# DEPARTMENT OF PUBLIC WORKS

## Price Boulevard Widening Project Update

May 23, 2017

Modified Typical Section

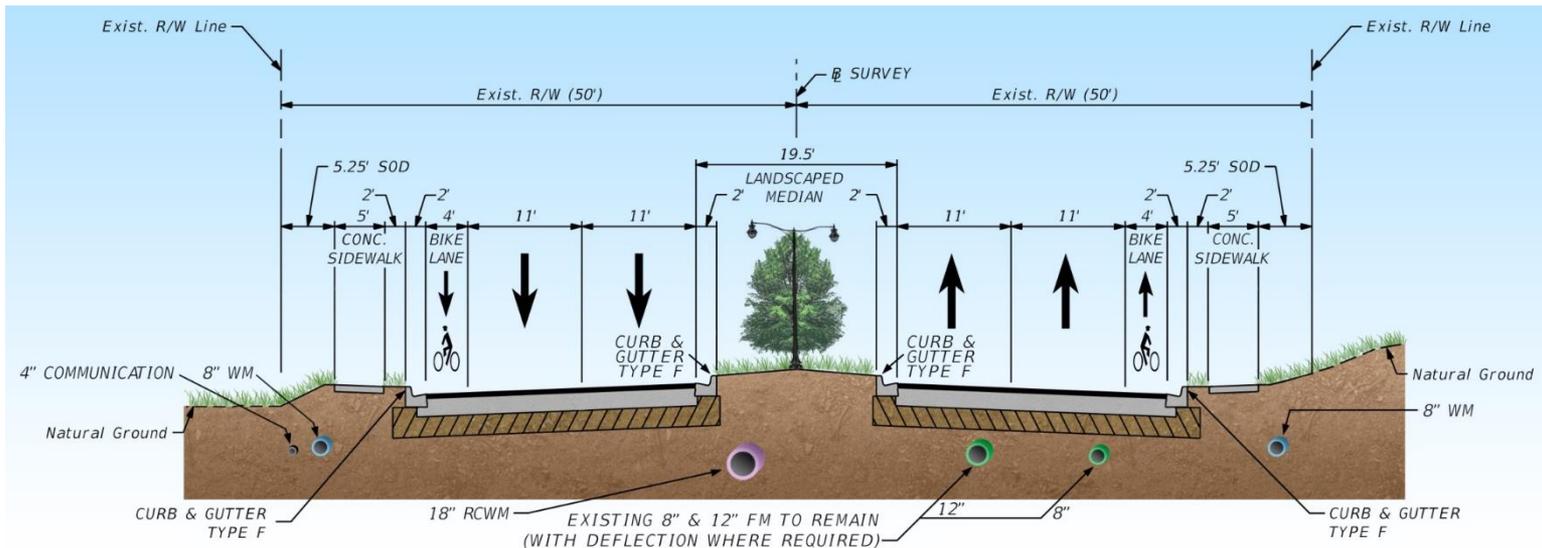
- Staff recommended typical cross-section modified from public comments:
  - Proposed posted 35 mph speed limit
  - Bicycle lanes reduced from 5' to 4'
  - Sidewalk width reduced from 8' to 5'
  - Raised center median with restricted access

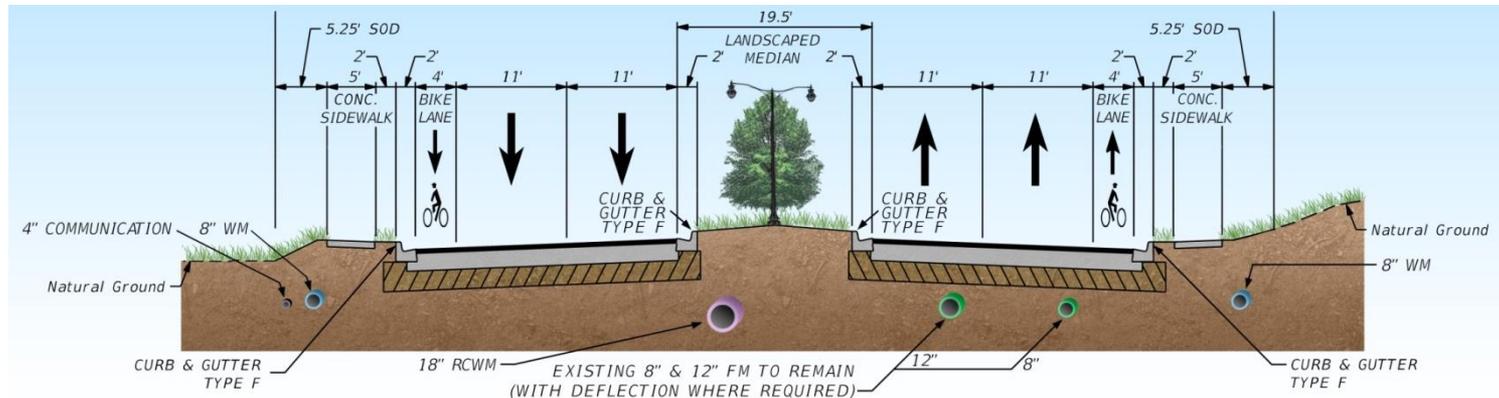
- Typical Section Comments
  - **Narrow Median – 4 comments**

- Increases distance between road edge and ROW line
- Potential to increase sidewalk and/or bike lane width

- Eliminates U-turns causing increase travel time to abutting properties along Price Blvd
- Impacts EMS mobility
- Reduces landscape opportunities
- Impacts street lighting if < 12 feet

Staff Recommendation: Maintain 19.5 foot median to facilitate U-turns, improve safety, landscaping and facilitate street lighting.

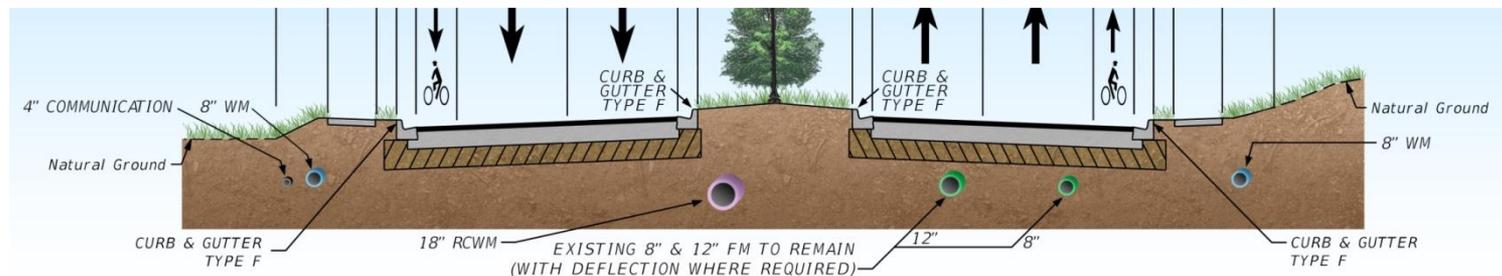
- Typical Section Comments
  - **Eliminate Median to provide more space – 6 comments**

- Allows direct access to driveways and cross streets
- Improve Emergency Management Services (EMS) mobility
- Increases distance between road edge and ROW line
- Potential to increase sidewalk and/or bike lane width

- Increases accident potential and severity
- Eliminates landscape opportunities in median
- Impacts street lighting
- Impacts capacity

Staff Recommendation: Maintain 19.5 foot median to facilitate U-turns, improve safety, accommodate landscaping and facilitate street lighting.

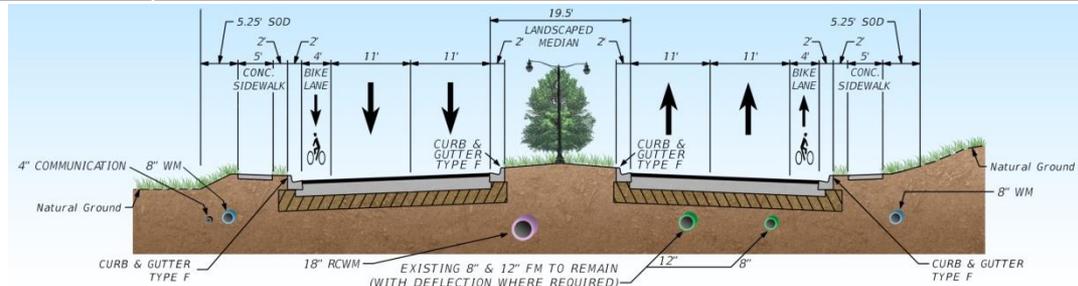
- Typical Section Comments
  - **3-Lanes – 4 comments**

- Accommodates left turns without blocking through traffic
- Significantly increases distance between road and ROW line
- Potential to increase sidewalk and/or bike lane width
- Maintains full access along Price Blvd with continuous two-way left turn lane
- Potential for service vehicles (UPS, lawn/pool maintenance) to park along side of road

- Does not improve capacity
- Continuous two-way left turn lane increase accident potential and severity
- Eliminates landscape opportunities in median
- Impacts street lighting
- Mail service and solid waste collection will block through lane

Staff Recommendation:  
Maintain a 4-lane section with  
median

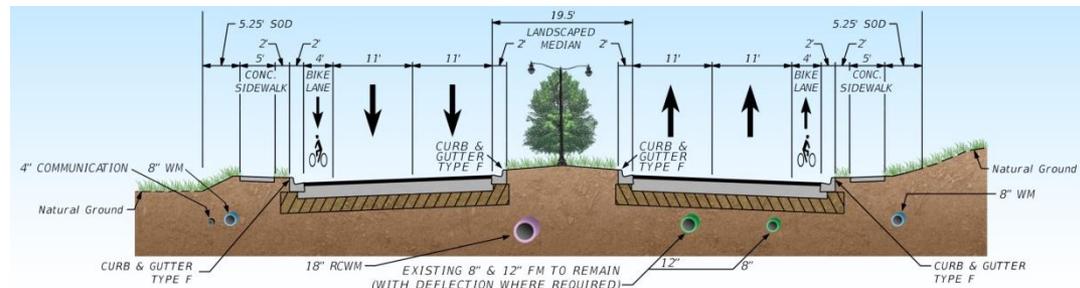
- Typical Section Comments
  - **5-Lanes – 1 comments**

- Accommodates left turns without blocking through traffic
- Slightly increases distance between road and ROW line
- Potential to increase sidewalk and/or bike lane width
- Maintains full access along Price Blvd with continuous two-way left turn lane
- Improves roadway capacity

- Continuous two-way left turn lane increase accident potential and severity
- Eliminates landscape opportunities in median
- Impacts street lighting

Staff Recommendation:  
Maintain a 4-lane section with median

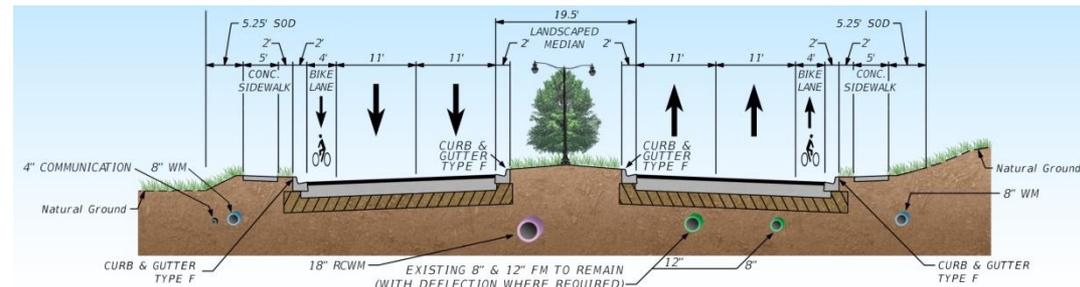
- Typical Section Comments
  - **Add Right Turn Lanes – 5 comments**

- Slight improvement in traffic flows with 4-lane section
- Larger improvement in traffic flows with 3-lane section

- Traffic analysis shows right turn lanes are not justified at any location for a 4-lane roadway
- Requires additional ROW with 4-lane divided or 5-lane roadways
- Increases construction and ROW costs

Staff Recommendation: Do not provide right turn lanes

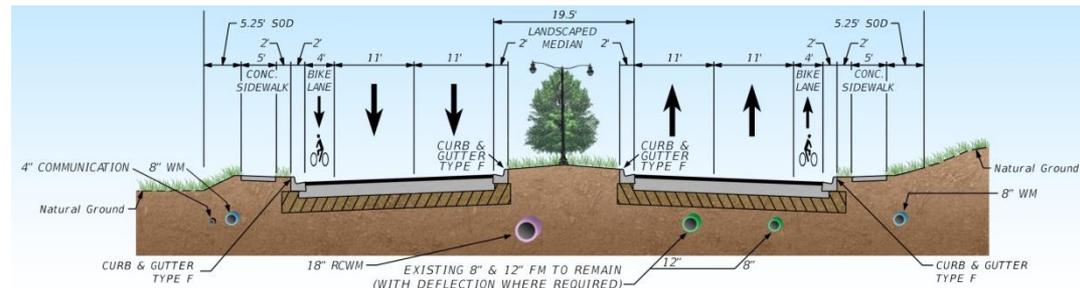
- Typical Section Comments
  - Do Nothing - 1 comments

- No impact to properties along Price Boulevard
- No construction disruptions

- Does not improve current traffic congestion
- Does not improve EMS response time
- Does not improve safety
- Does not meet City plan

Staff Recommendation: Do not adopt No Build alternative

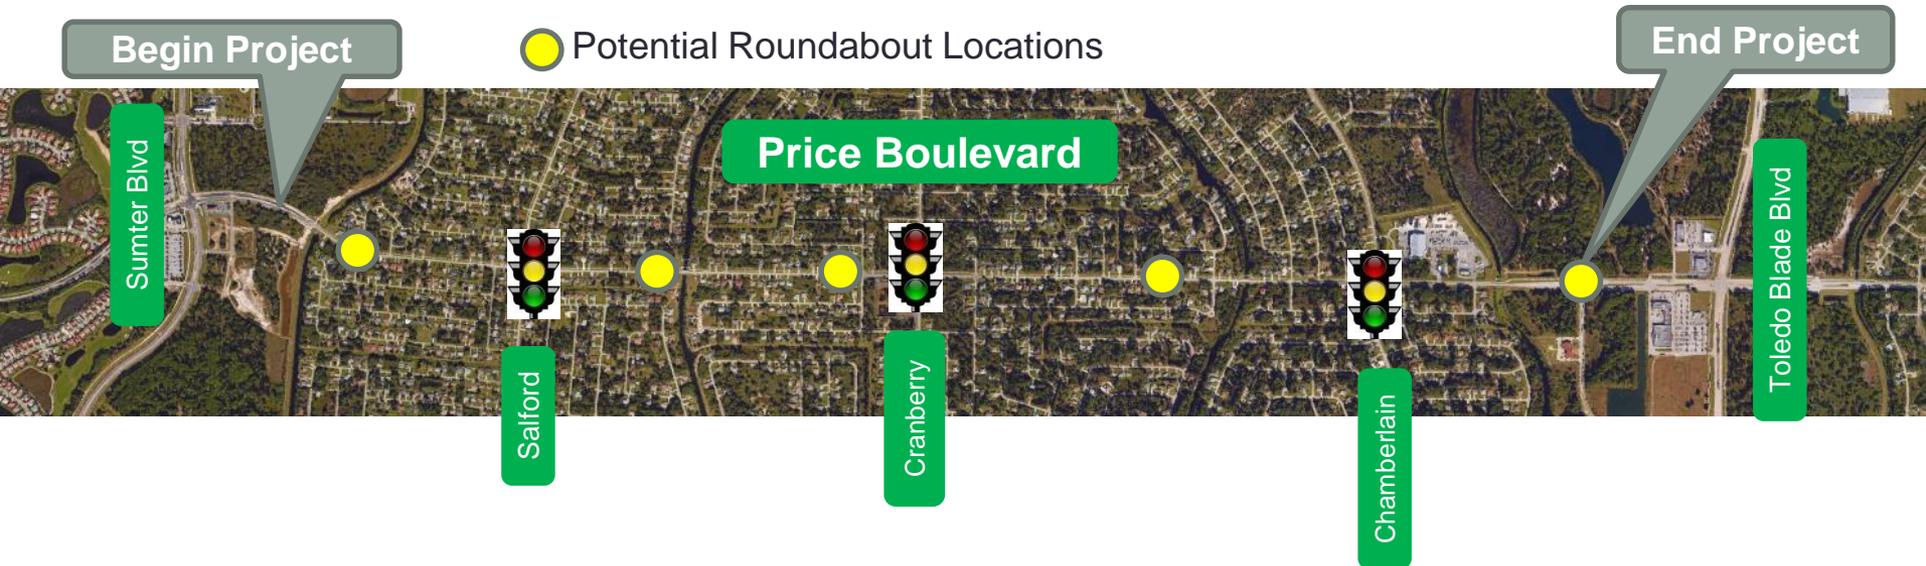
### • Use Roundabouts - 3 comments

- Increases distance between road edge and ROW line by decreasing median width
- Potential to increase sidewalk and/or bike lane width
- Improves ease of U-turns
- Improves safety for U-turning vehicles
- Decreases severity of accidents
- Physically controls speed along Price
- Potentially eliminates one or more existing signals
- Improves drainage design to accommodate off-site runoff
- Reduces impacts to almost all properties
- Eliminates future maintenance when signal is replaced with roundabout

- Requires additional study to determine roundabout locations and cost implications
- Requires additional ROW at existing non-signalized intersections at roundabout locations and possibly at signalized intersections
- Delays project design schedule
- Negative public perception
- Increases number of minor accidents

Staff Recommendation: Not utilize roundabouts to avoid additional ROW impacts as compared to use of the modified typical section.

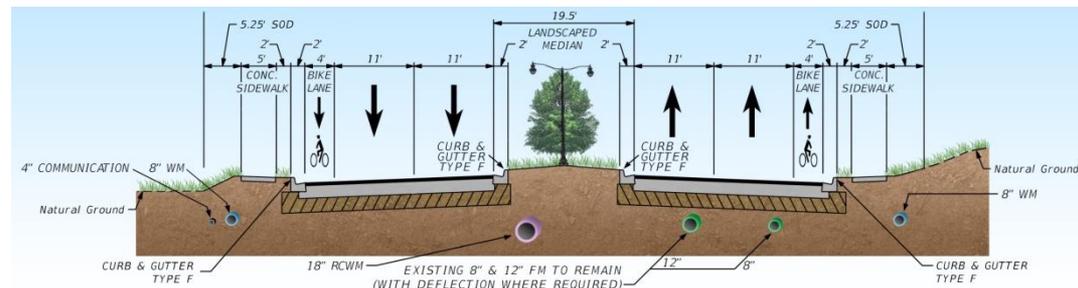
- Typical Section Comments
  - **Purchase additional ROW to provide at least 120 feet – 8 comments** (requires purchasing parcels along one side of Price Boulevard)

- Meets ULDC ROW width
- Increases distance between road edge and ROW line
- Potential to increase sidewalk and/or bike lane width
- Reduces impacts to properties (eliminates need for easements, provides space for parking)
- Potential for frontage road which improves access for remaining houses along one side
- Improves drainage design

- Requires buying properties along one side of Price Boulevard
- Increases ROW and construction costs
- Residential relocations
- Potentially delays design and construction

Staff Recommendation: Not recommended due to funding limitations

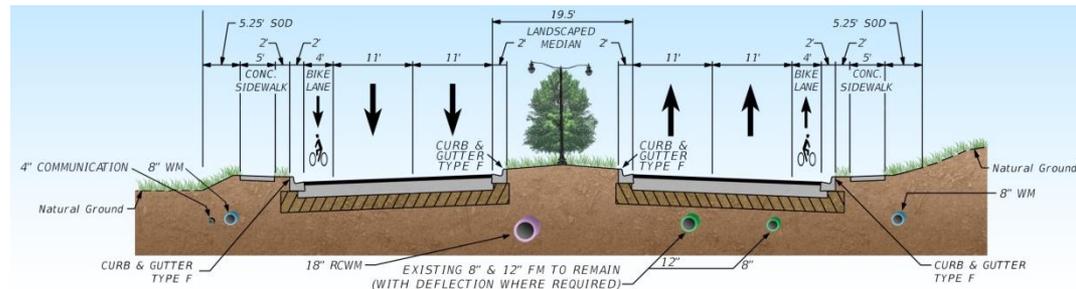
- Bike Lanes
  - **Eliminate – 9 comments**

- Increases distance between road edge and ROW line
- Potential to increase sidewalk width

- Eliminates U-turns
- Impacts EMS mobility
- Not desired by cycling community
- Forces bicyclists on sidewalk creating safety issues

Staff Recommendation: Keep bike lanes

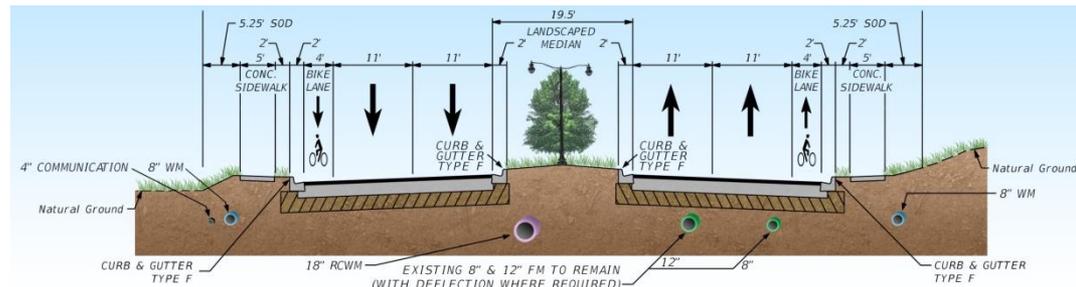
- Bike Lanes
  - Keep – 4 comments

- Preferred by cycling community
- Safer for cycling community
- Safer to separate cyclist from pedestrians
- Maintains U-turns

- Maintains edge of roadway closer to ROW line

Staff Recommendation: Keep bike lanes

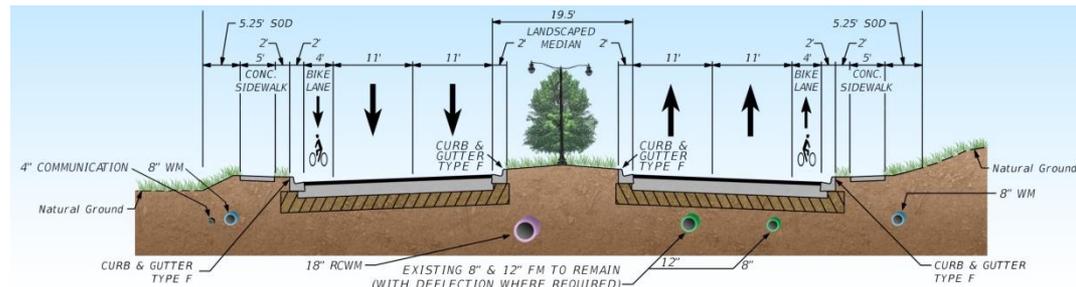
- Bike Lanes – eliminate bike lanes and use:
  - Use Two Shared-use Paths – 5 comments
  - Use One Shared-use Path and no sidewalk on other side – 2 comments

- Eliminates U-turns
- Decrease safety on shared-use path
- Not feasible to eliminate bike lanes and provide only one path
- Does not promote alternative mode of transportation
- Not desired by cycling community

Staff Recommendation: Keep bike lanes

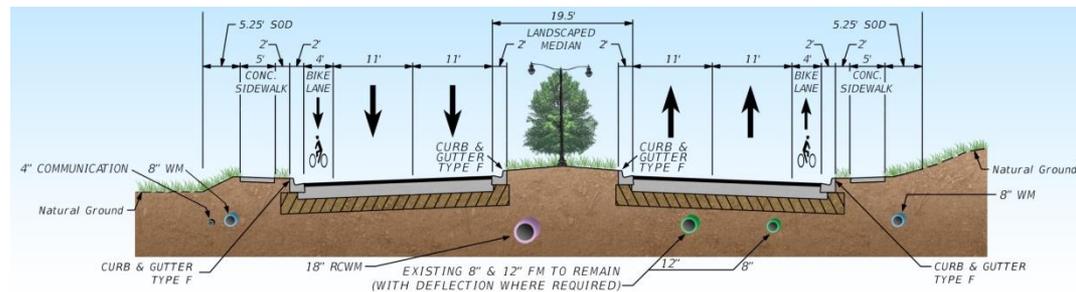
- Eliminate Sidewalks – 2 comments
- Use One Sidewalk – 3 comments

- Provides more space for tying into existing ground at ROW
- Reduces impacts to properties

- Not safe for pedestrians
- Not safe for casual bicyclists
- Does not meet ULDC

Staff Recommendation: Keep sidewalk along both sides

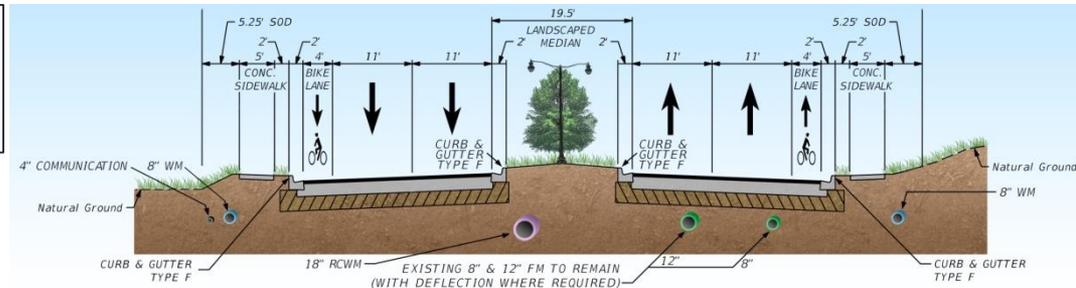
- Keep – 2 comments

- Eliminate – 2 comments

- Eliminating reduces maintenance costs
- Reduces construction costs
- Provides visual buffer

- Eliminating reduces aesthetics along corridor
- Eliminating is not consistent with other City arterials

Staff Recommendation: Keep landscaping

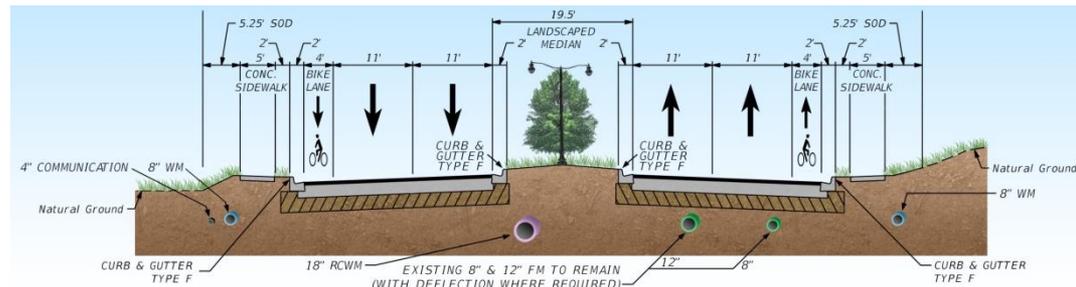
- Proposed Speed Limit of 35 mph
  - Raise – 2 comments
  - Lower – 6 comments

- Lowering speed limit perceived to be more fitting for a residential area
- Lowering speed limit improves safety for vehicles accessing driveways

- Lowering speed limit not consistent with arterial classification
- Lowering speed limit becomes enforcement issue
- Raising speed limit not appropriate for residential area

Staff Recommendation: Keep posted speed limit at 35 mph
